# Access Compliance Report

## Public Rights-of-Way

Intersection ID: 3114	Main Street: BROWNESTONE_VIEW_DR	Cross Street: RIDGELINE_LN	Location: W
ADA ID: CD21E244DD6F	Ramp Type: PerpDiag	Initial Pass/Fail: Fail	Overall Compliance: No
Severity Score: 10			
Codes/Mitigation Info/Possible Solution		Field Measurements/Component Compliance

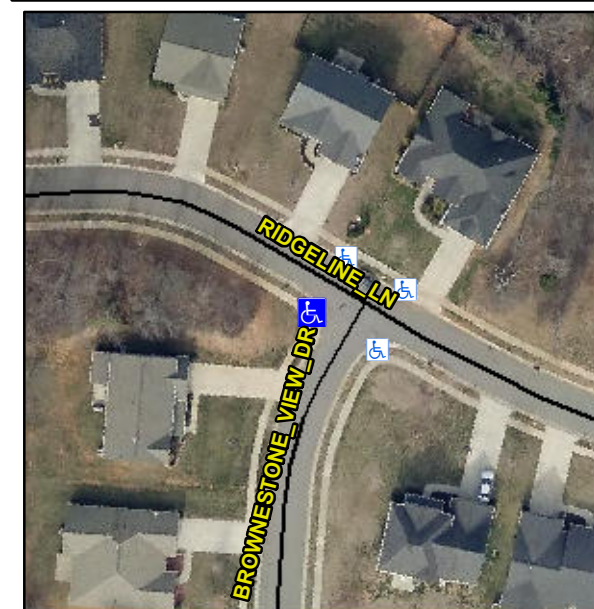
**Not Found, R304.5.1, R304.5.3**

Compliance	Description	Data	Compliance	Description	Data
N/A	Ramp Length (in)	48.0	Yes	Ramp Slope (%)	5.1
No	Ramp Width (in)	46.0	No	Ramp XSlope (%)	3.8
N/A	Flare Type LT	N/A	N/A	Flare Type RT	N/A
N/A	Flare Slope LT (%)	N/A	N/A	Flare Slope RT (%)	N/A
N/A	Flare Traversable LT?	N/A	N/A	Flare Traversable RT?	N/A
N/A	Landing Length (in)	N/A	N/A	DWS Provided?	N/A
N/A	Landing Width (in)	N/A	N/A	DWS Contrast?	N/A
N/A	Landing Slope (%)	N/A	N/A	DWS Length (in)	N/A
N/A	Landing X Slope (%)	N/A	N/A	DWS Full Width?	N/A
N/A	Landing Curb? (Y/N)	N/A	N/A	DWS Offset (in)	N/A
N/A	Shared Landing?	N/A			
N/A	Gutter Ponding?	N/A	N/A	Gutter Slope (%)	N/A
N/A	Gutter Lip Ht (in)	N/A	N/A	Gutter X Slope (%)	N/A
N/A	Painted X Walk1?	No	N/A	Painted X Walk2?	No
	X Walk 1 Direction	To SE		X Walk 2 Direction	To NE
N/A	X Walk 1 Width (in)	N/A	N/A	X Walk 2 Width (in)	N/A
	X Walk 1 Slope (%)	2.2		X Walk 2 Slope (%)	5.4
	X Walk 1 X Slope (%)	5.3		X Walk 2 X Slope (%)	1.4

**Remove & Replace Curb Ramp With Two New Directional Ramps or Equivalent.**
